CITY OF BOULDER
PLANNING BOARD STUDY SESSION AND MEETING AGENDA
DATE: December 5, 2013
TIME: 6 p.m.
PLACE: West Boulder Senior Center, 909 Arapahoe Avenue

AGENDA TITLE: Public hearing to consider **Concept Plan**, no. LUR2013-00049, for the phased subdivision and redevelopment of the 45.5-acre Western Disposal Services site at 2655 N. 63rd St. to include sites for light industrial and technology development businesses as well as a potential waste transfer station and public access drop-off facility adjacent to the existing compost facility. The site is zoned IM (Industrial- Manufacturing).

DATE OF COMMENTS:	**October 11, 2013**
CASE MANAGER:	**Chandler Van Schaack**
PROJECT NAME:	**Western Industrial Park Concept Plan Review**
LOCATION:	**2655 N 63RD ST**
COORDINATES:	**N03E02**
REVIEW TYPE:	**Concept Plan Review & Comment**
REVIEW NUMBER:	**LUR2013-00049**
APPLICANT:	**Nancy Blackwood for Western Disposal Services**
DESCRIPTION:	**Concept Plan Review for Western Industrial Park. Proposed 45.5 acre site to include new industrial uses and a potential waste transfer station for Western Disposal.**

1 CONCEPTUAL SITE PLAN

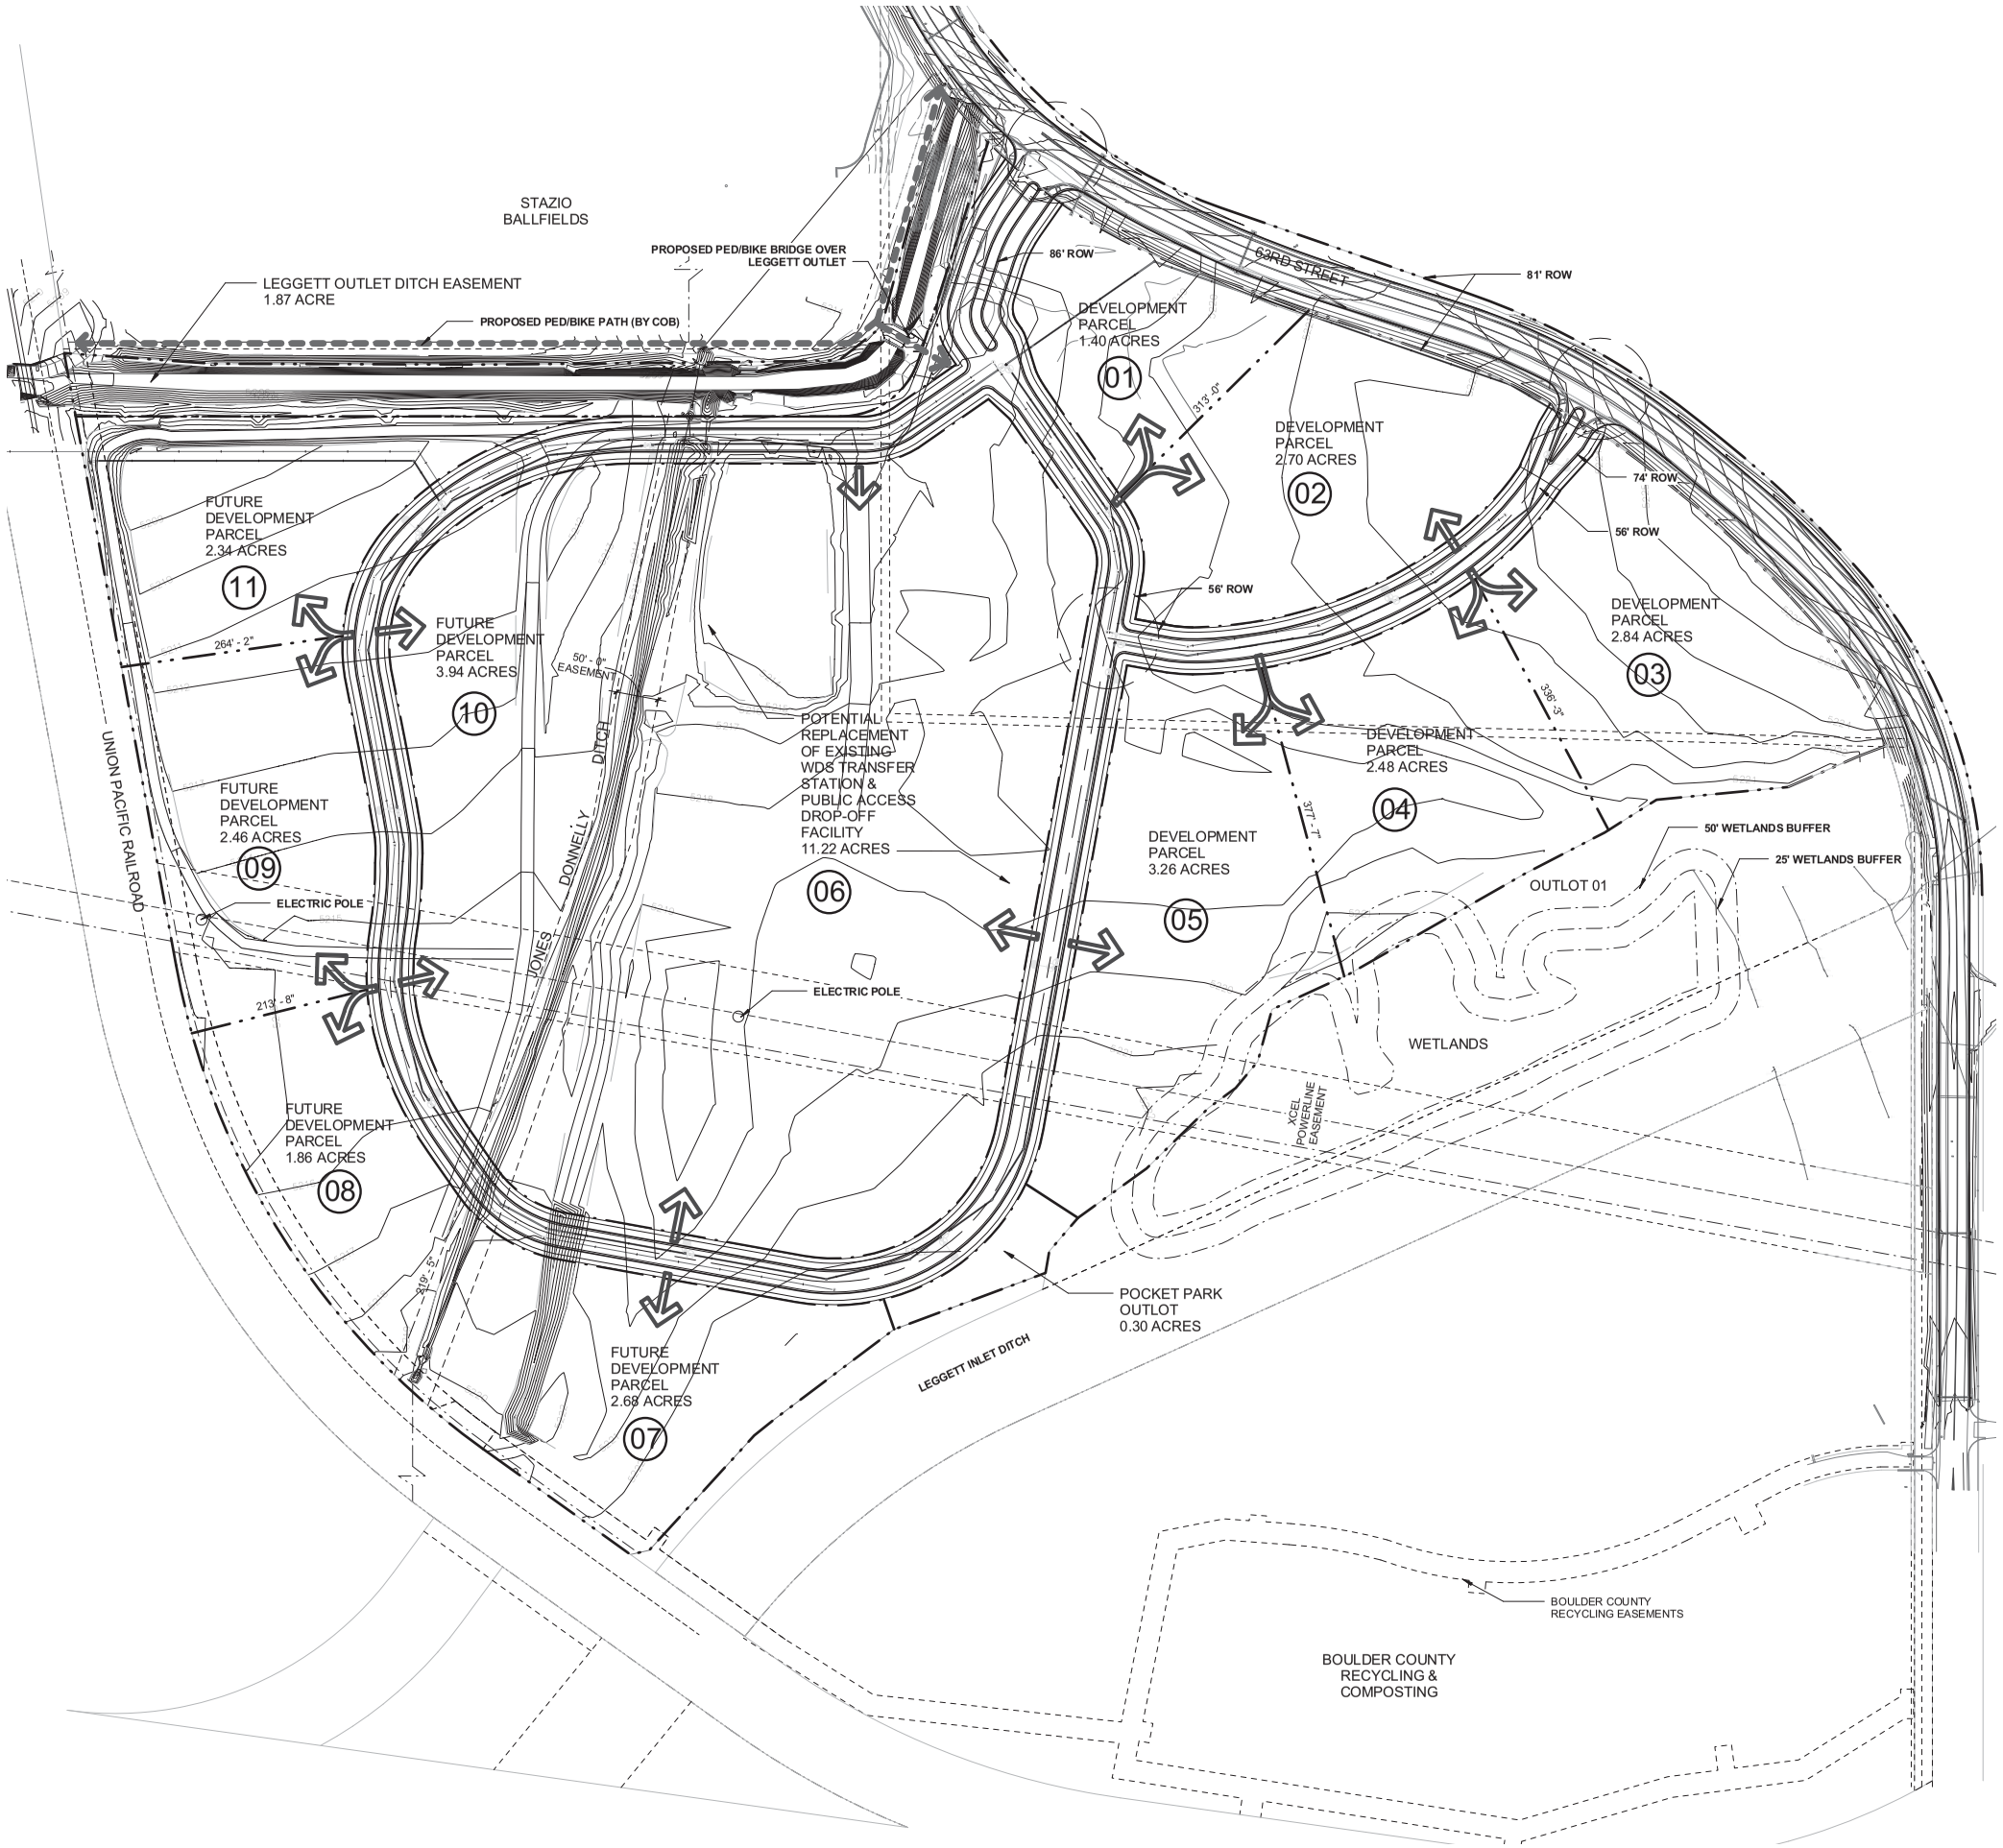
2. The internal streets must provide a minimum paved street section width of 36-feet (curb face to curb face) as shown in Table 2-3 of the DCS. Please note the right-of-way width will need to be increased in order to accommodate the minimum paved street section.

3. At time of site plan submittal, a traffic study and transportation demand management (TDM) plan must be completed for the build-out of the site. Staff is available to meet with the applicant to discuss the parameters of the traffic study and TDM Plan.

4. At time of site plan submittal and pursuant to Section 9-9-7 of the Boulder Revised Code (BRC) sight triangles must be shown at street intersections.

5. At time of site plan submittal and per Section 2.10(D)(4) of the DCS, the site submittal must show that the north and south entrances from North 63rd Street and the street intersection within the site can accommodate the minimum turning radius of an SU-30 emergency vehicle.

1. Per Section 5.10 of the City of Boulder *Design and Construction Standards (DCS)* all distribution mains shall be looped into the existing water system to ensure at least two feed sources and to maintain system strength. Only one connection to the existing system is shown on the plans.
